REMARKS

Drawings

Red-lined drawings are attached hereto, as shown:

FIG. 3B

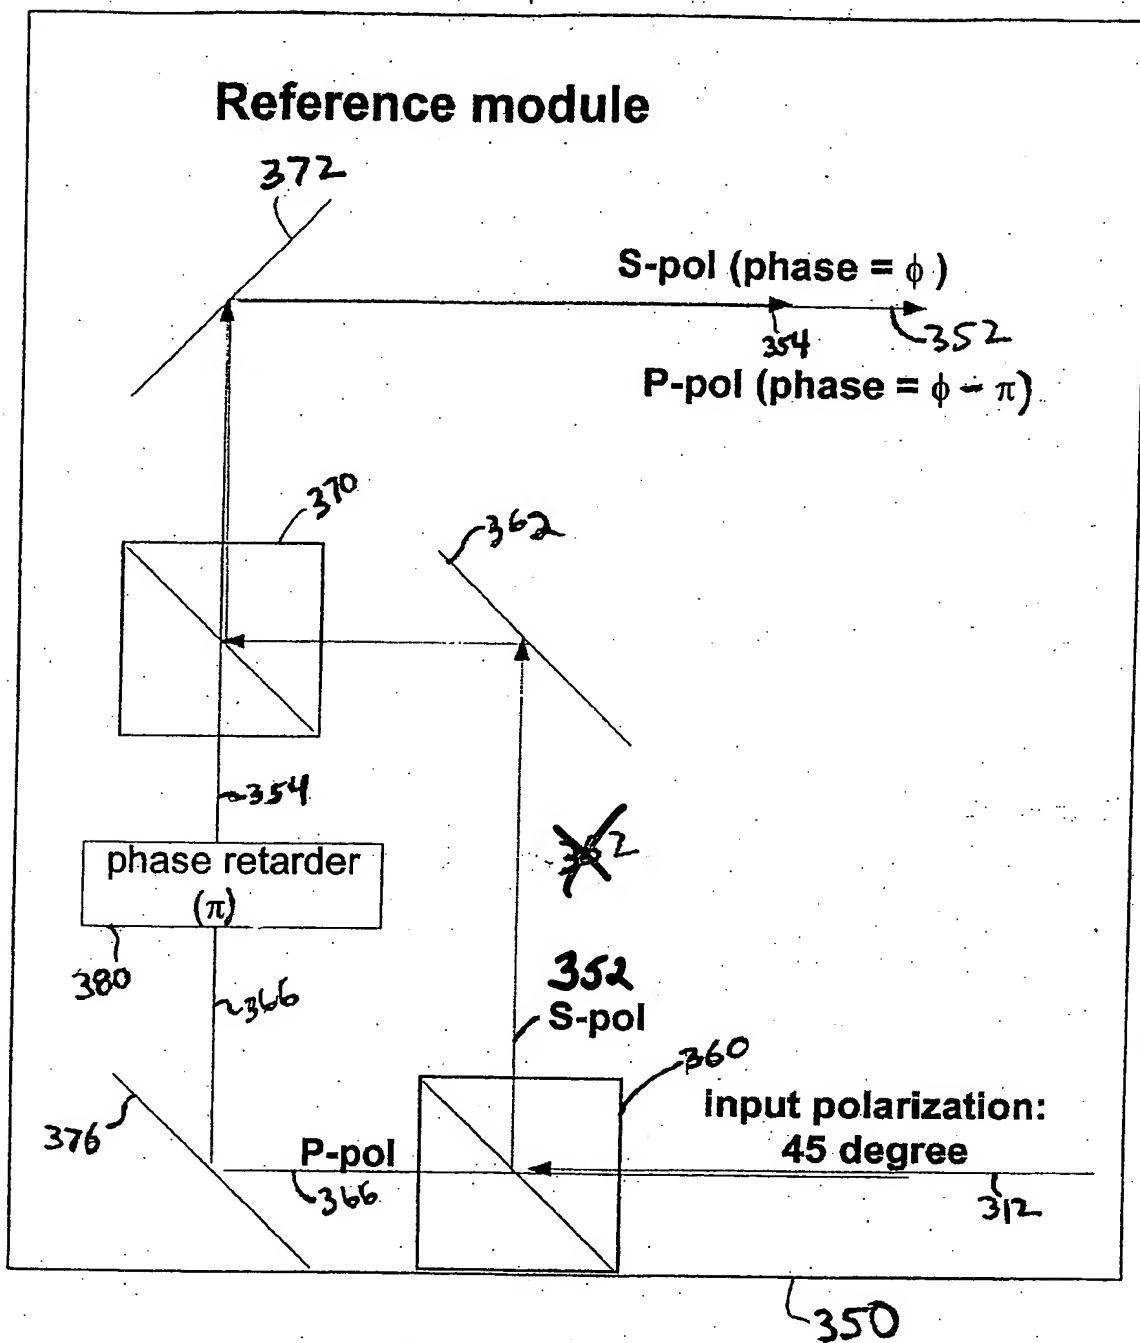
FIG. 3B (sheet 4/13) more closely places element number 352 to S-pol;

FIG. 6C

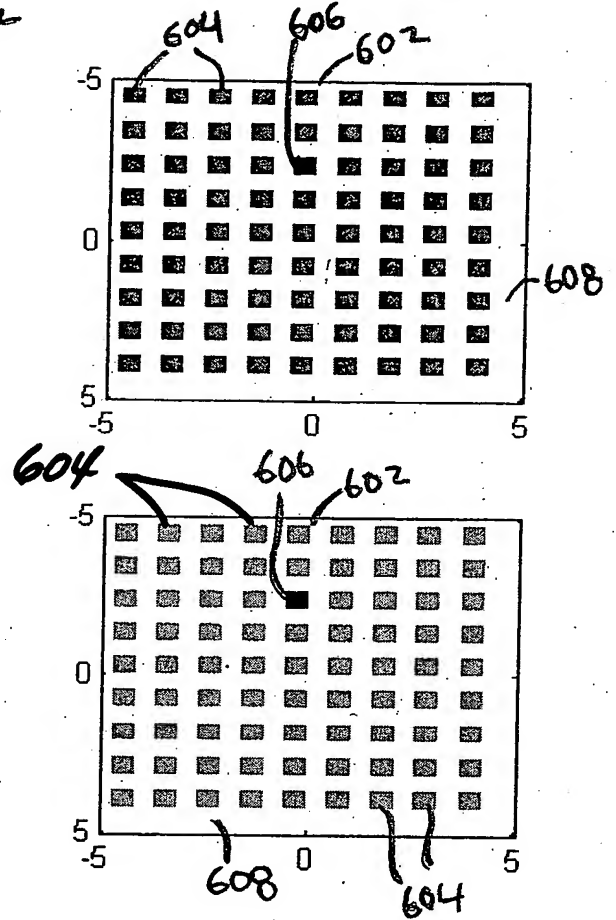
FIGs. 6C and 6D (sheet 7/13) add the element numbers 604 and their respective lead lines;

FIG. 8

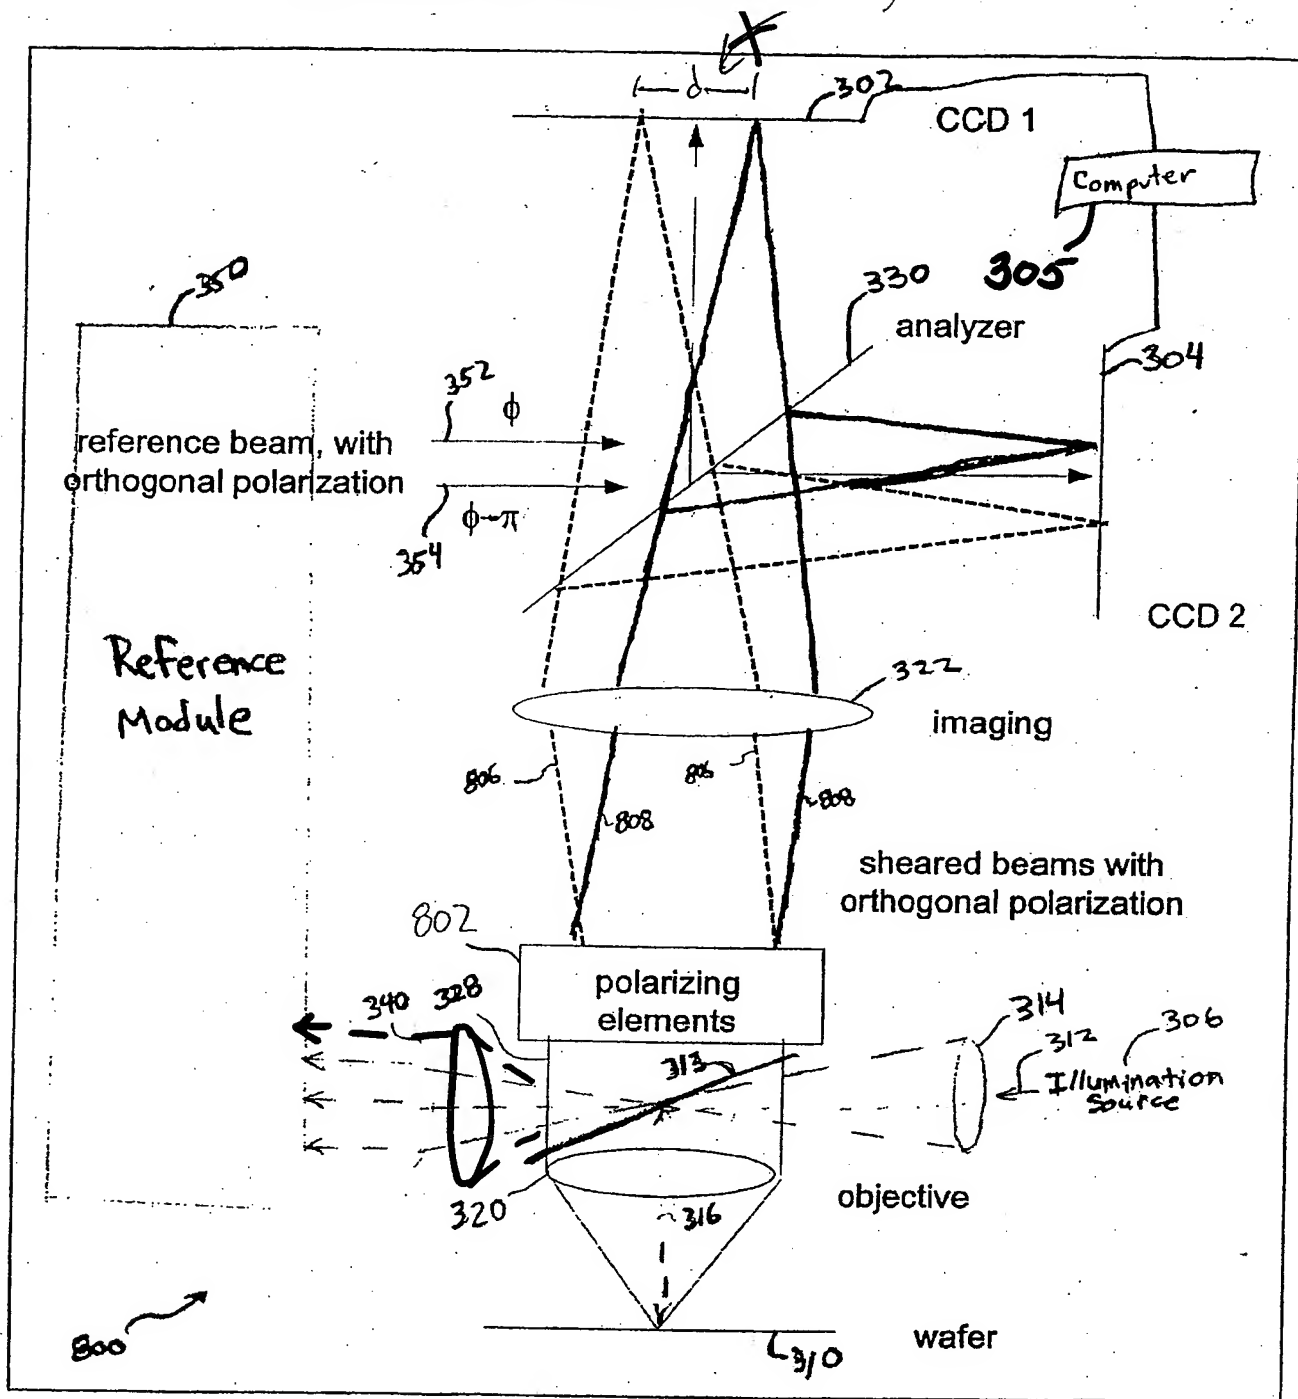
FIG. 8 (sheet 8/13) shows an element 340 that is shown faintly in the original drawings as filed.

Figure 12C. The simulated signal plot at the CCD through differential interference detection. The object in ~~the~~ simulation is illustrated in Figure 7.

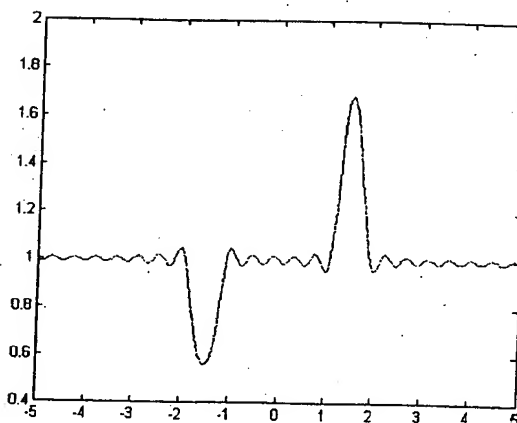
FIG. 12C (sheet 13/13) deletes the extraneous word "is" in the text as shown.
